Addendum No. 01

File Reference Number: RFP 2025 067

Title: RRC Whitson Office Renovation

RE: Clarifications/Questions

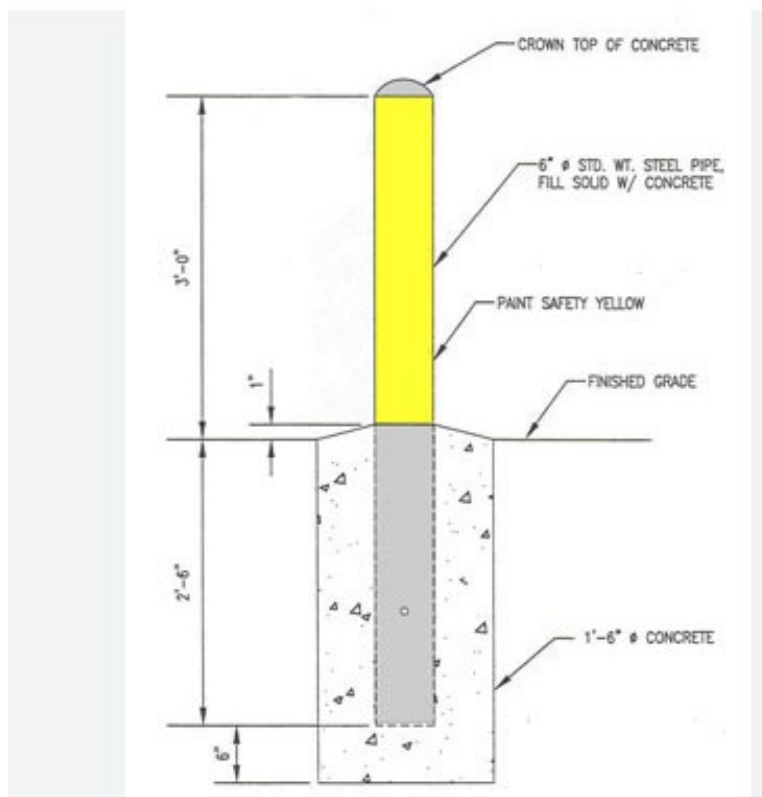
Item 8: Can ONTC provide direction on bollard installation requirements?

Answer: The typical bollard detail shown below is acceptable:

title
ELECTRICAL
SITE PLAN
NOTES AND DETAILS

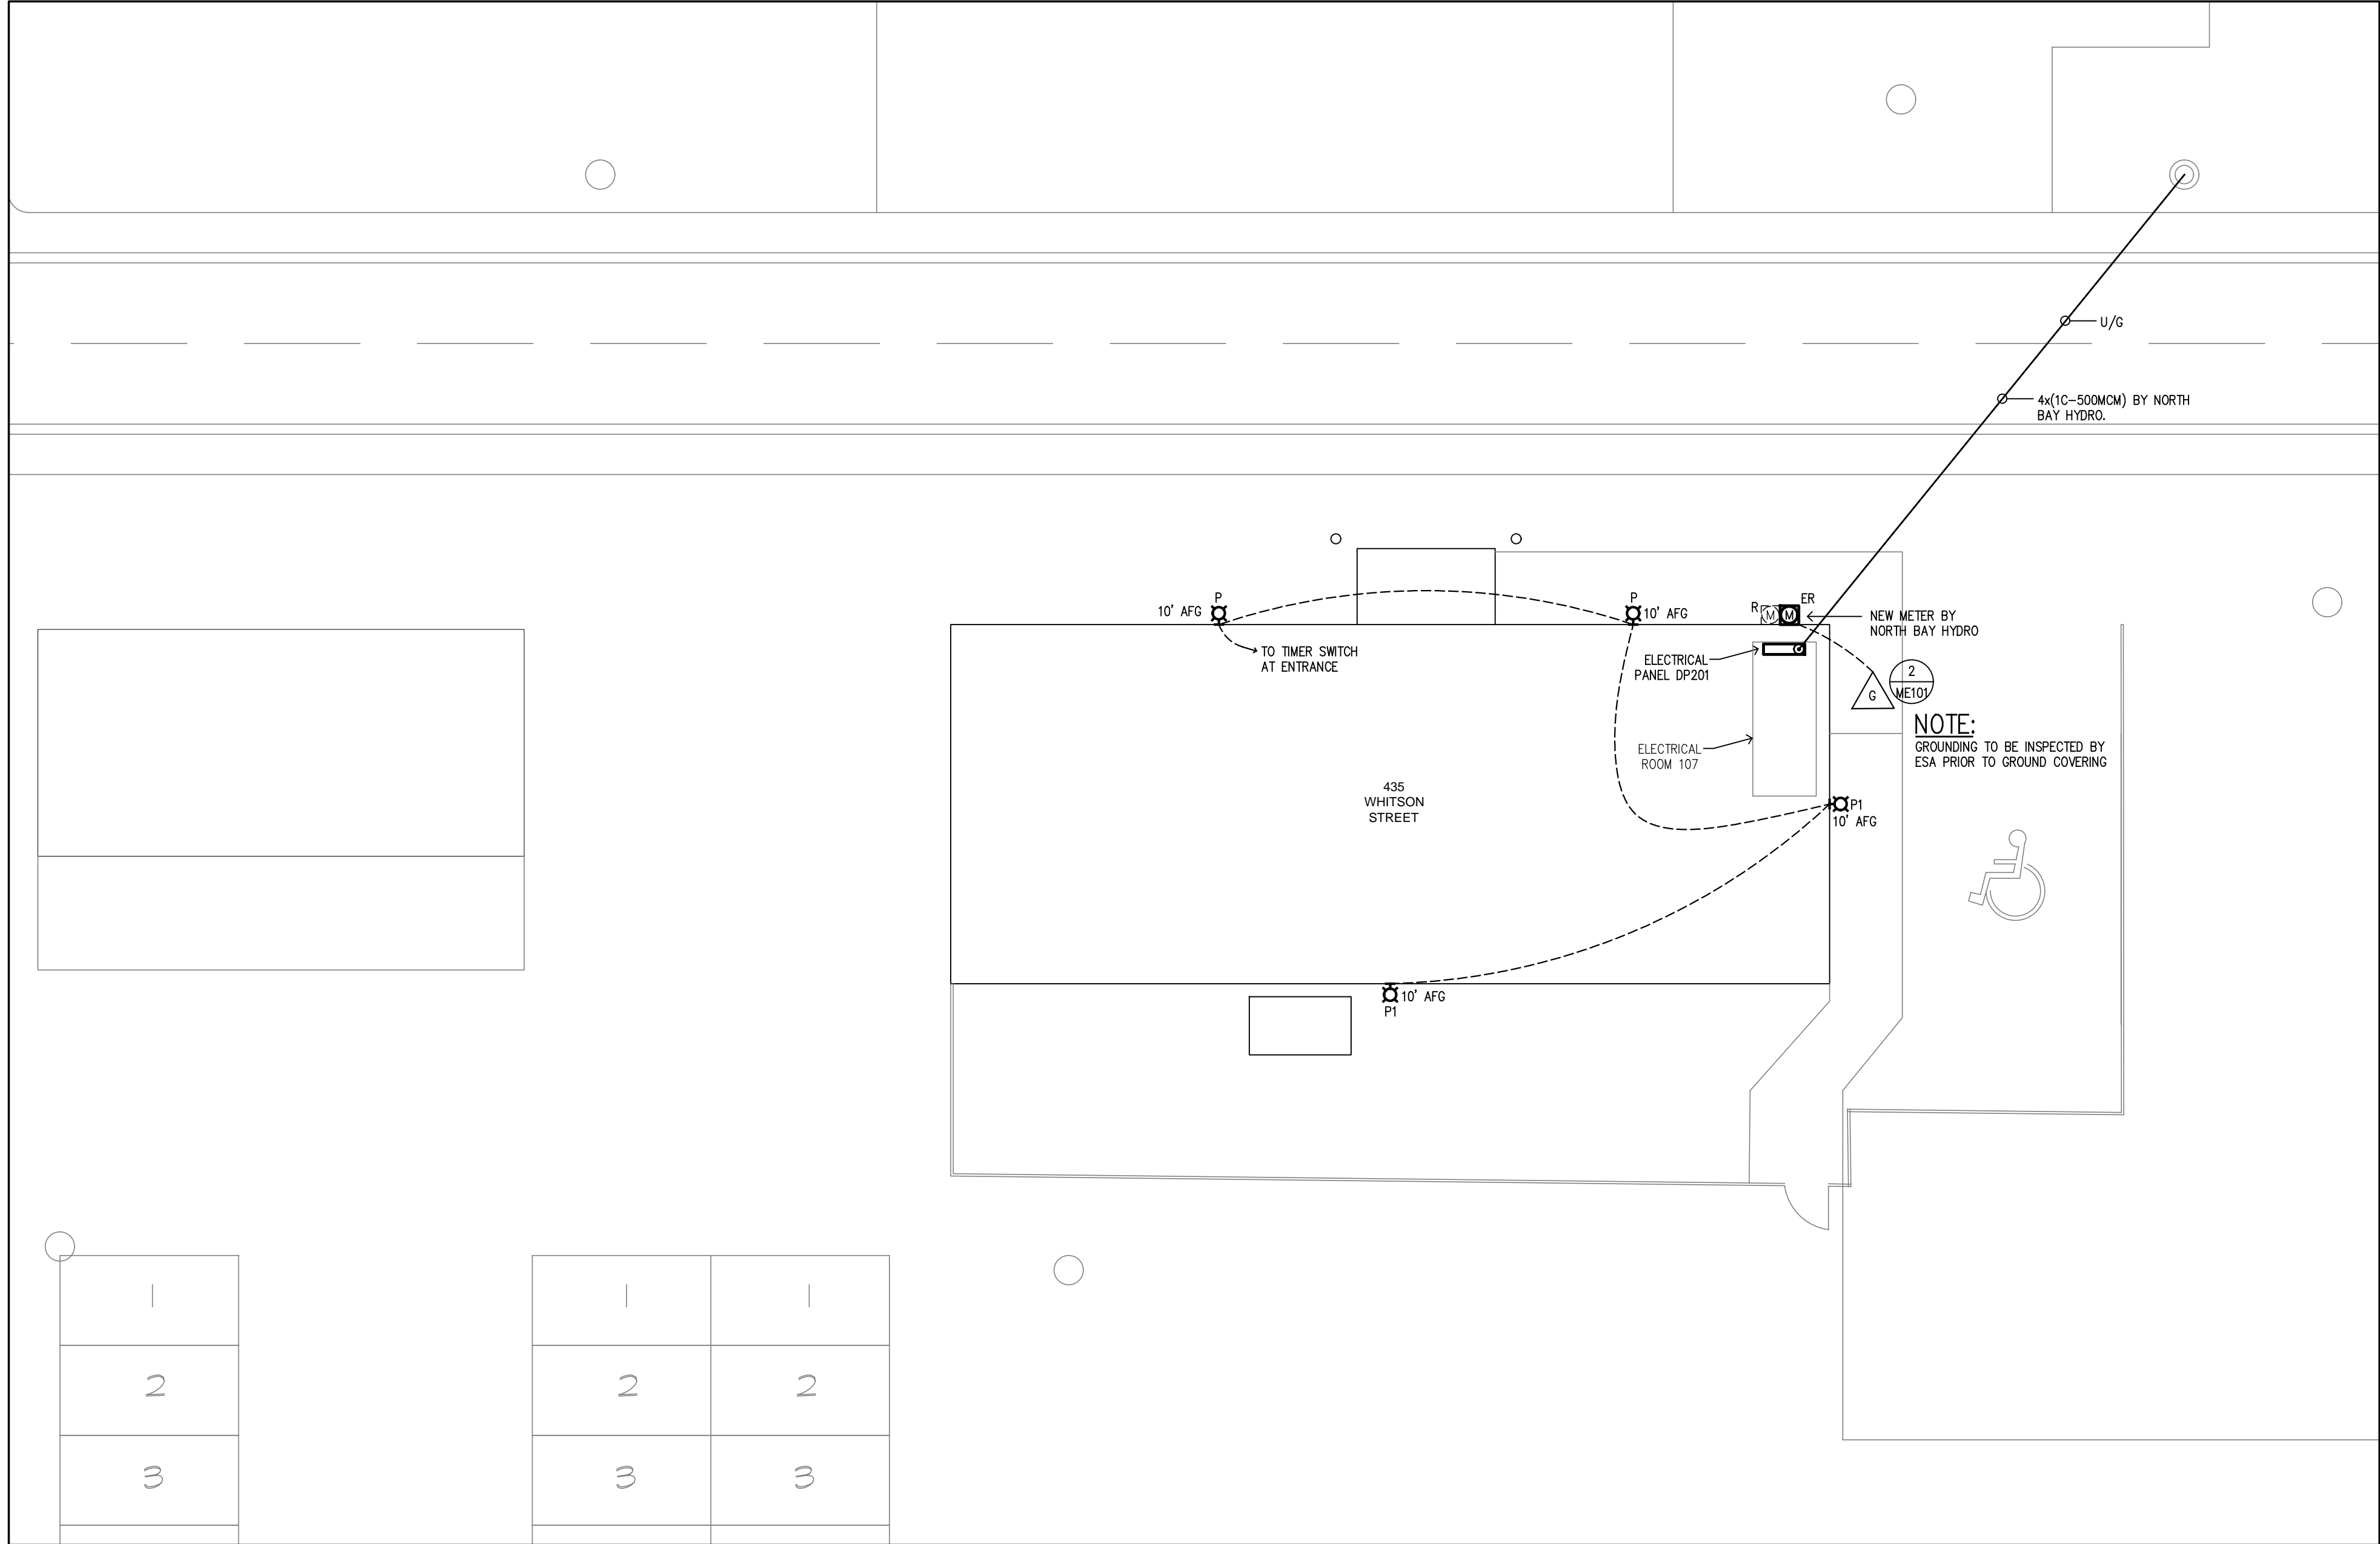
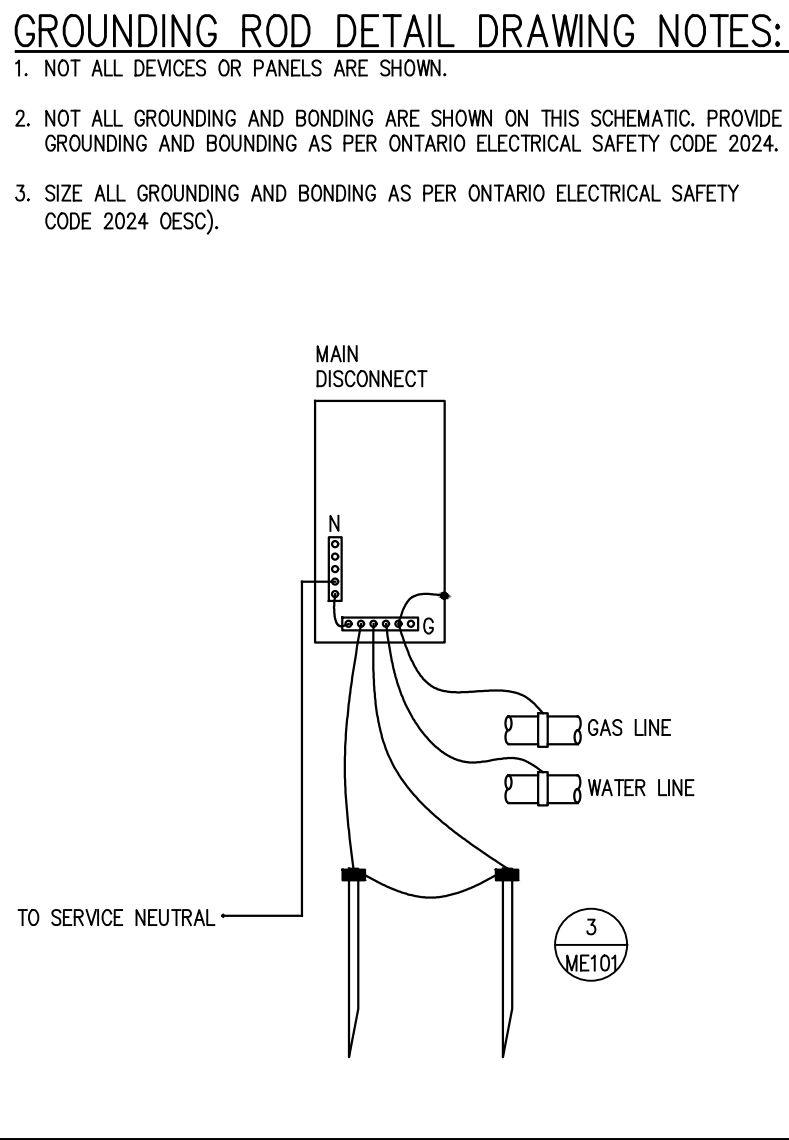
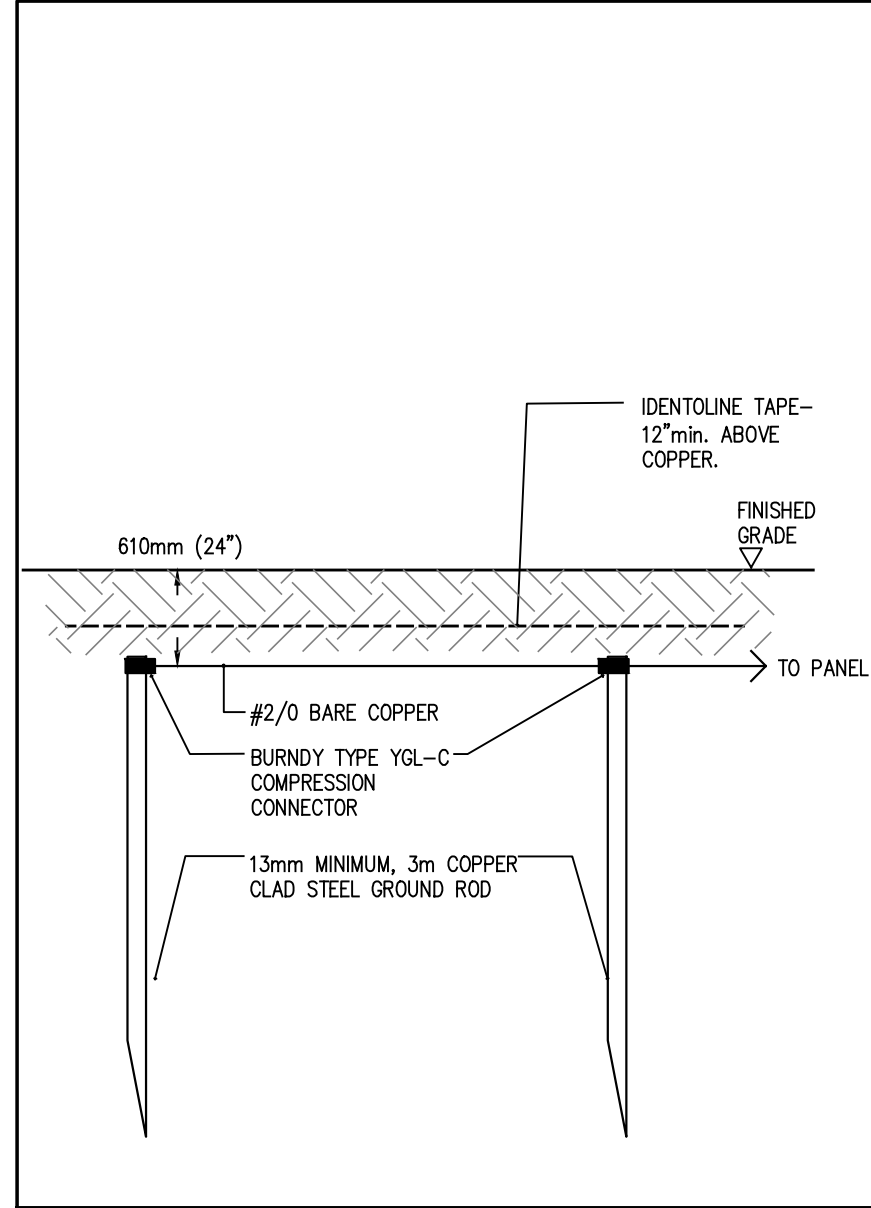
1. Add Drawing ME101 – Electrical Site Plan Notes & Details.
